**AMENDMENT 11: Physical layers and
management parameters for 100 Gb/s
and 400 Gb/s operation over single-
mode fiber at 100 Gb/s per wavelength**

IEEE Std 802.3cu™-2021

Amendment 11: Physical Layers and Management Parameters for 100 Gb/s and 400 Gb/s Operation over Single-Mode Fiber at 100 Gb/s per Wavelength

Figure 140–1—100GBASE-DR, 100GBASE-FR1, and 100GBASE-LR1 PMD relationship to the ISO/IEC Open Systems Interconnection (OSI) reference model and IEEE 802.3 Ethernet model

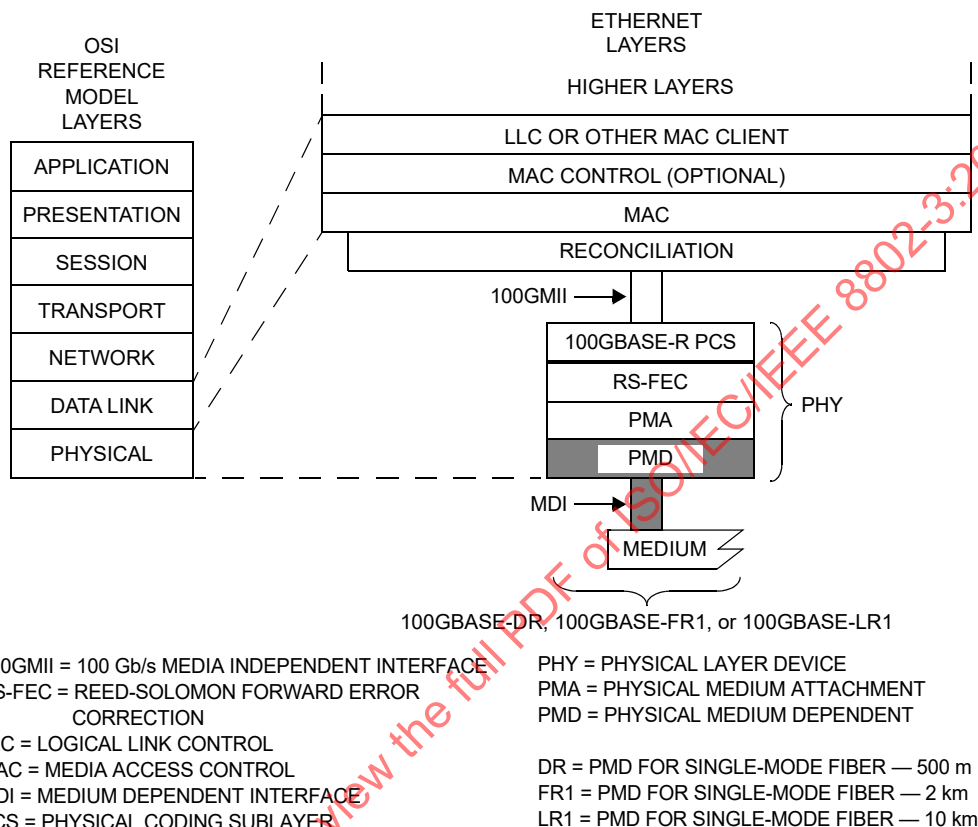
Replace Figure 140–1 and change the title as follows:

Figure 140–2—Block diagram for 100GBASE-DR, 100GBASE-FR1, or 100GBASE-LR1 transmit/receive paths

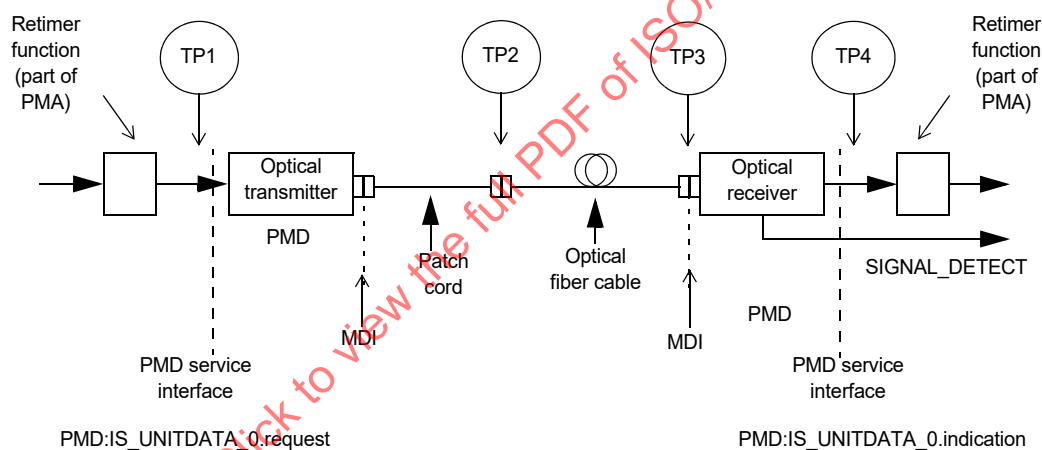
Change the title of Figure 140–2 as follows:

Figure 140–2a— OMA_{outer} (max) and OMA_{outer} (min) versus TDECQ for 100GBASE-FR1 and 100GBASE-LR1

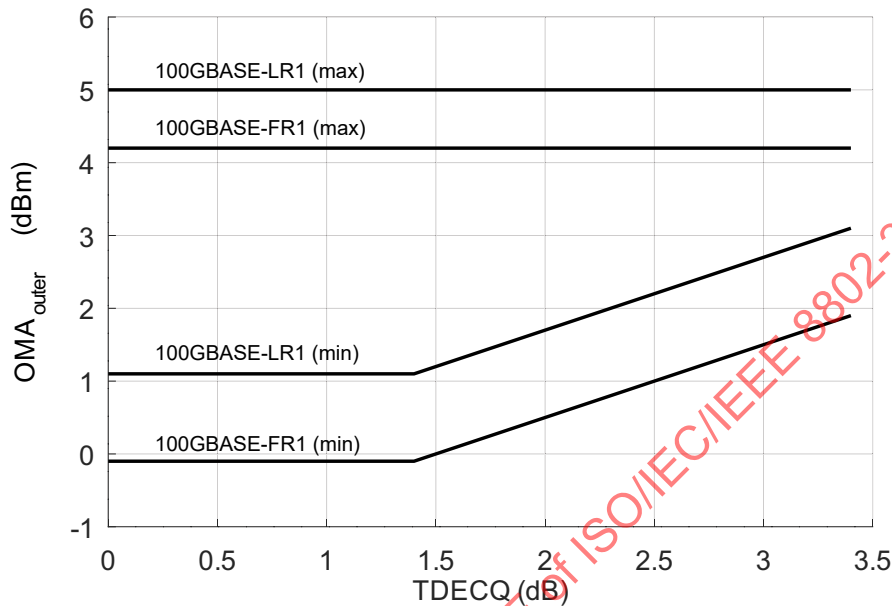
Insert new text and Figure 140–2a at the end of 140.6.1 as follows:

The values for OMA_{outer} (min) in Table 140–6 vary with TDECQ. Figure 140–2a illustrates this for 100GBASE-FR1 and 100GBASE-LR1, along with the values for OMA_{outer} (max).

Figure 140-2b—Receiver sensitivity (OMA_{outer}) (max) for 100GBASE-FR1 and 100GBASE-LR1

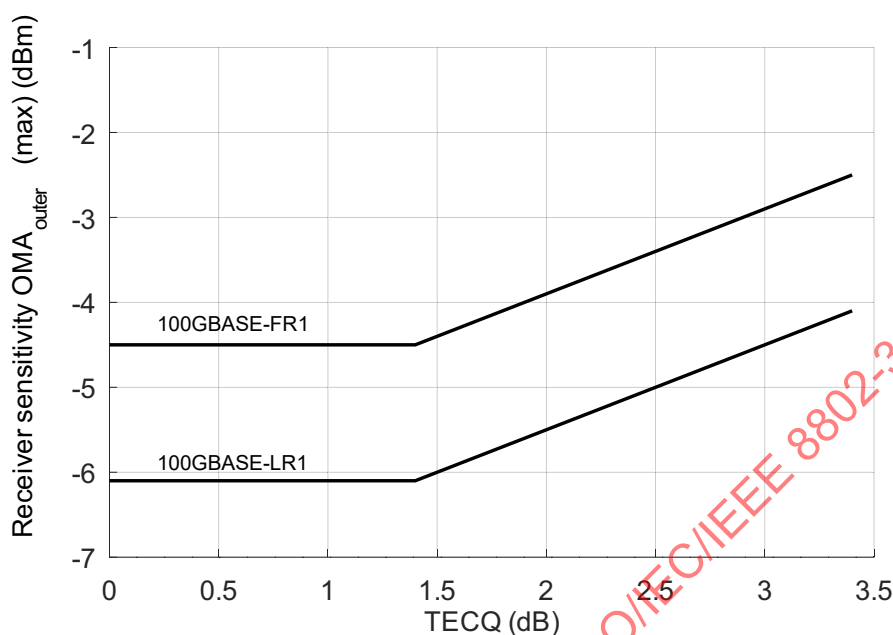
Insert new text and Figure 140–2b at the end of 140.6.2 as follows:

The values for receiver sensitivity (OMA_{outer}) (max) in Table 140–7 vary depending on the value of TECQ of the test source used for measurement. Figure 140–2b illustrates this for 100GBASE-FR1 and 100GBASE-LR1.

Figure 140-2c—Transmitter OMA_{outer} versus TDECQ and receiver sensitivity (OMA_{outer}) versus TECQ for 100GBASE-FR1

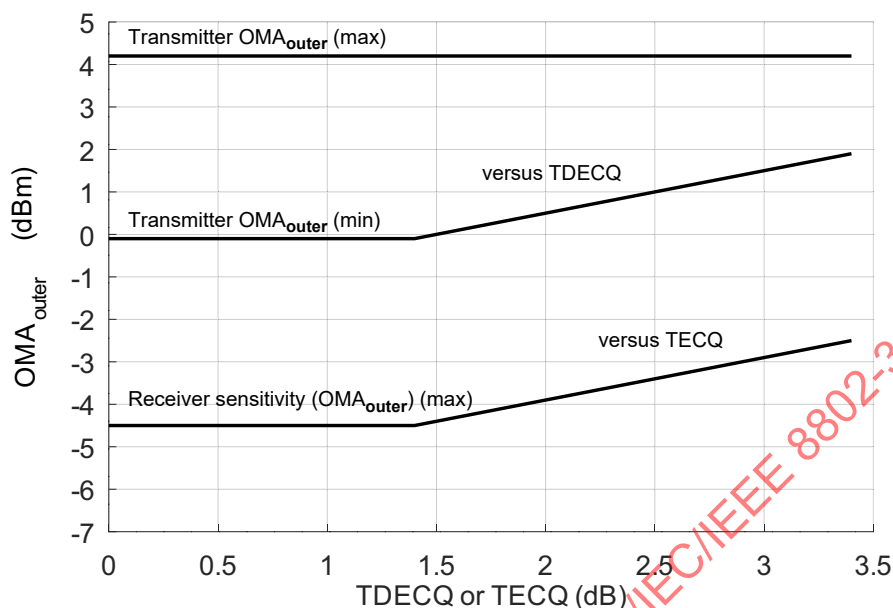
Insert new text, Figure 140–2c, and Figure 140–2d at the end of 140.6.3 as follows:

The values of transmitter OMA_{outer} (max), transmitter OMA_{outer} (min) versus TDECQ, and receiver sensitivity (OMA_{outer}) (max) versus TECQ are illustrated in Figure 140–2c for 100GBASE-FR1 and in Figure 140–2d for 100GBASE-LR1.
